Patagonia Area Resource Alliance

January 12, 2024

**Re: Comments and Objections to Proposed Renewal of AZPDES Permit
(AZ0026387) for South32 Hermosa, Inc.**

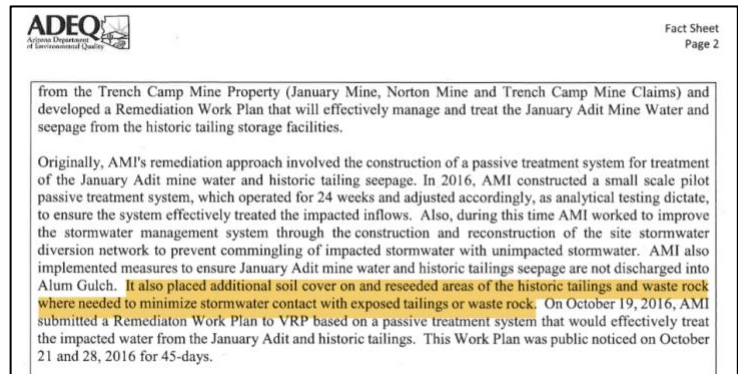
In a clear effort to avoid the TMDL and other requirements discussed above applicable to discharges from Outfall 001 into impaired Alum Gulch, ADEQ includes the following prohibition in the Draft Permit at Part I(A)(1)(b) that ADEQ’s own materials demonstrate is untethered from reality: “The only allowable discharges from Outfall 001 are drainage water from historic workings associated with the January Adit, drainage water from historic tailings, and stormwater. See definition of ‘historic’ in Appendix A, Part B of the Draft Permit. If South32 does seek to add dry stack tailings from a future mill to the existing tailings storage facility, they must notify ADEQ and cease discharge to Alum Gulch.” The Draft Fact Sheet (below) contains similar language.

ADEQ states that these restrictions are to ensure “that no new sources will be discharged to an impaired water as required by the *San Carlos* decision.” (Draft Fact Sheet at 6).²⁷

AZPDES No. AZ0026387 Draft Fact Sheet at 2 (Jan. 2018), emphasis added

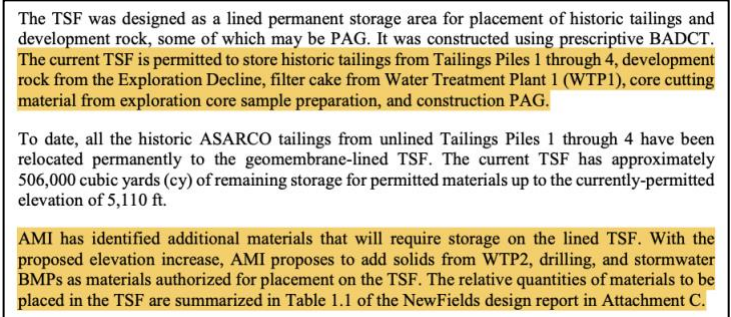
The 2018 Fact Sheet for the initial issuance of this AZPDES Permit (above, left) plainly states that historic tailings materials were commingled with additional materials containing new sources of pollution, such as soil and waste rock since at least 2016, even before the old historic unlined tailings piles were moved and restructured into the current TSF.

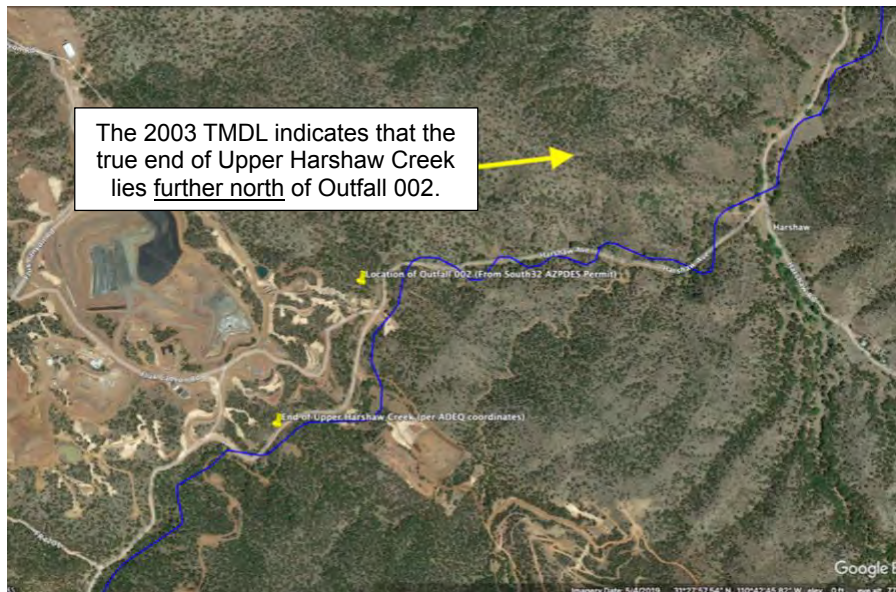
Recently, ADEQ has asserted (without evidence) that Outfall 002 is located in Lower Harshaw Creek. As a result, ADEQ takes the position that South32's planned discharge from Outfall 002 is to a segment of the Creek that is not listed under 303(d) for impairment. This conclusion is not supported by any evidence, does not comport with ADEQ's original listing for Upper Harshaw Creek, and it is contrary to ADEQ's own data.

ADEQ's TMDL DESCRIPTION OF THE END OF UPPER HARSHAW CREEK

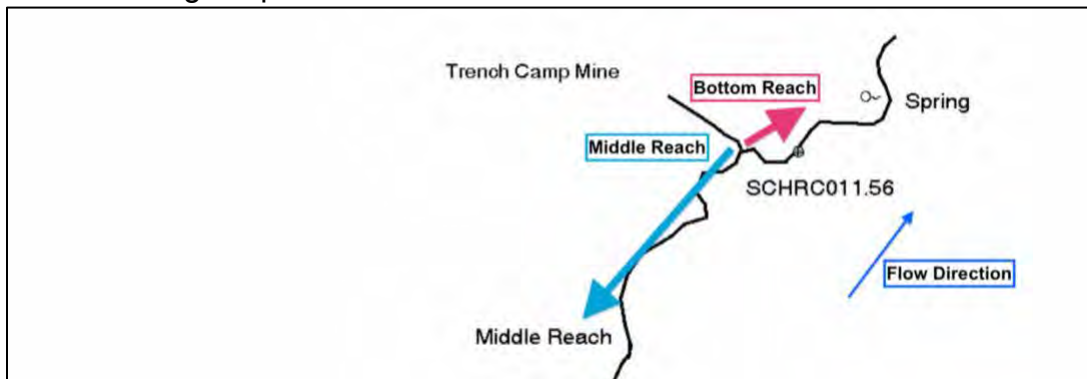
In an effort to "validate" its apparent redefinition of Upper and Lower Harshaw Creek, ADEQ has (without basis) used new GPS coordinates to denote the endpoint of Upper Harshaw in a different location that is conveniently above Outfall 002. However, these GPS coordinates were never referenced in the original 303(d) listing or the 2003 TMDL. Rather, these coordinates appear to have been perfunctorily generated after the fact, and they directly conflict with ADEQ's own description of Upper Harshaw Creek contained in the original 2003 TMDL. The TMDL indicates that the full length of listed Upper Harshaw Creek extends beyond these coordinates.

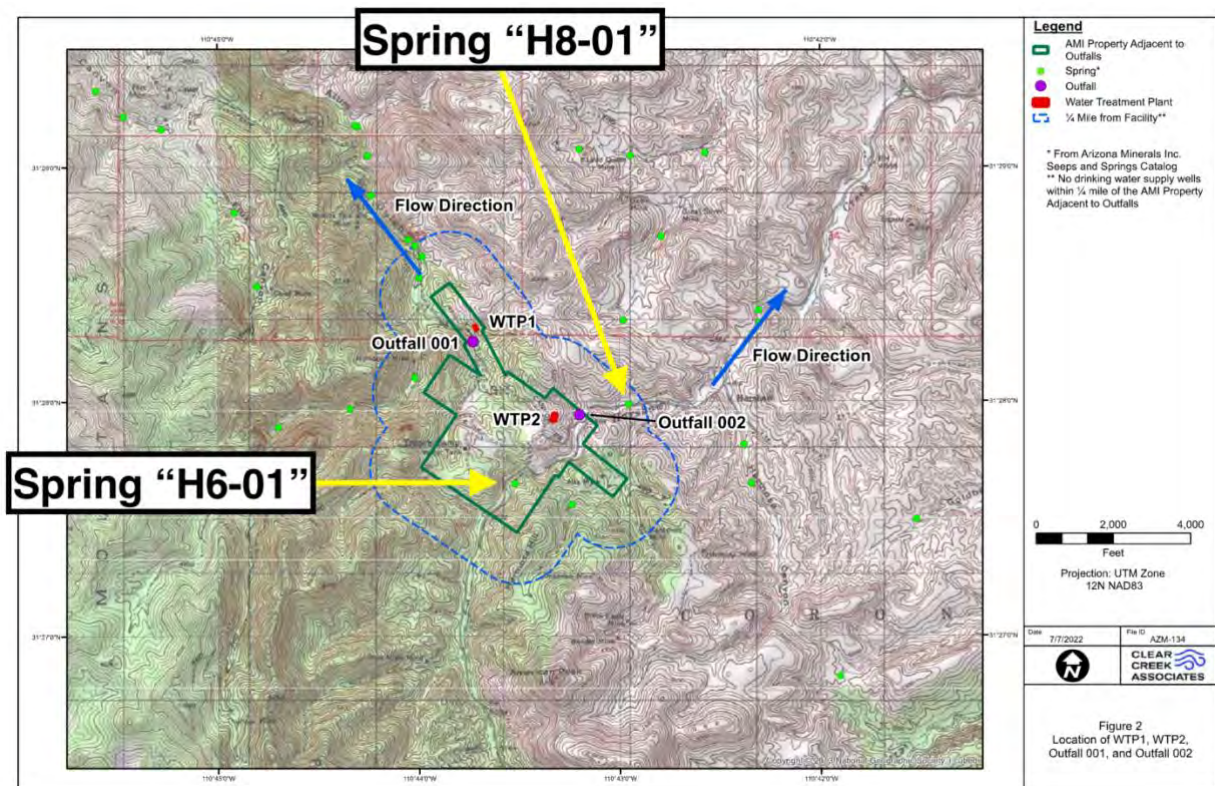
First, H6-01 is located south of sample point SCHRC011.56, which directly conflicts with the TMDL maps and descriptions of the end point spring. While the TMDL correctly documents the presence of more than one spring in this area (which is supported by the map above),⁹ only one spring is noted in the TMDL as marking the end of Upper Harshaw Creek. And the TMDL indicates this spring is located much further north than H6-01.

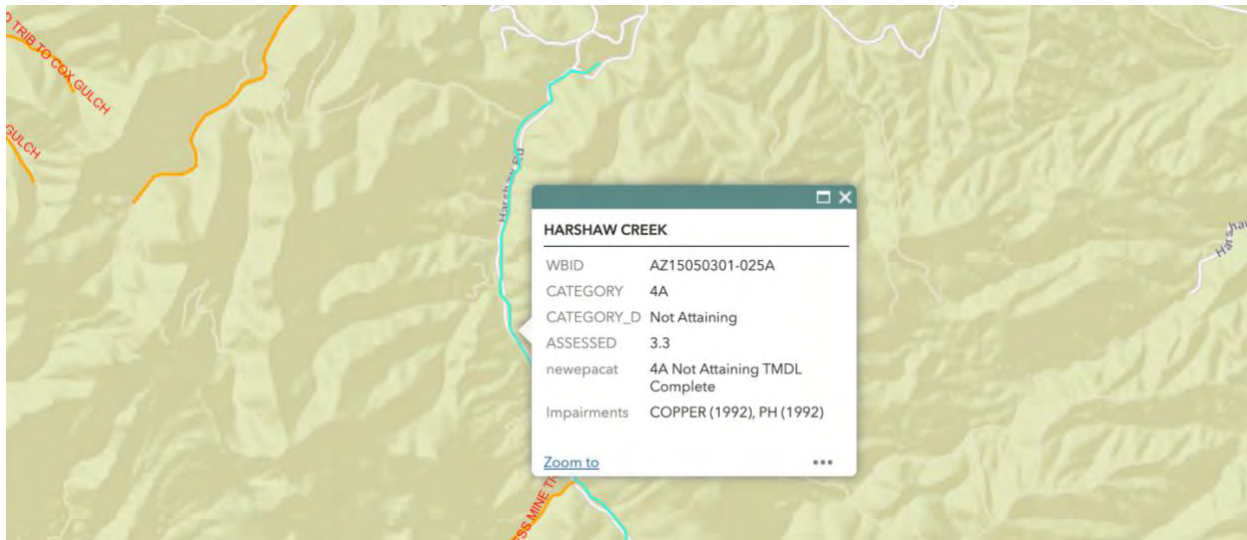
PARA has been unable to locate any basis for ADEQ’s convenient contraction of the apparent extent of “Upper Harshaw Creek” to just above Outfall 002. These specific coordinates are absent from the text of ADEQ 2003 Upper Harshaw Creek TMDL. They are also absent from all associated TMDL materials obtained and reviewed from that time, and their origins are presently unclear. So far, they only appear in materials dating after the TMDL was completed. In addition, PARA has been unable to locate any information to justify this apparent (*de facto*) “removal” of the bottom extent of Upper Harshaw Creek from the CWA 303(d) list, if this is, in fact, ADEQ’s intent.
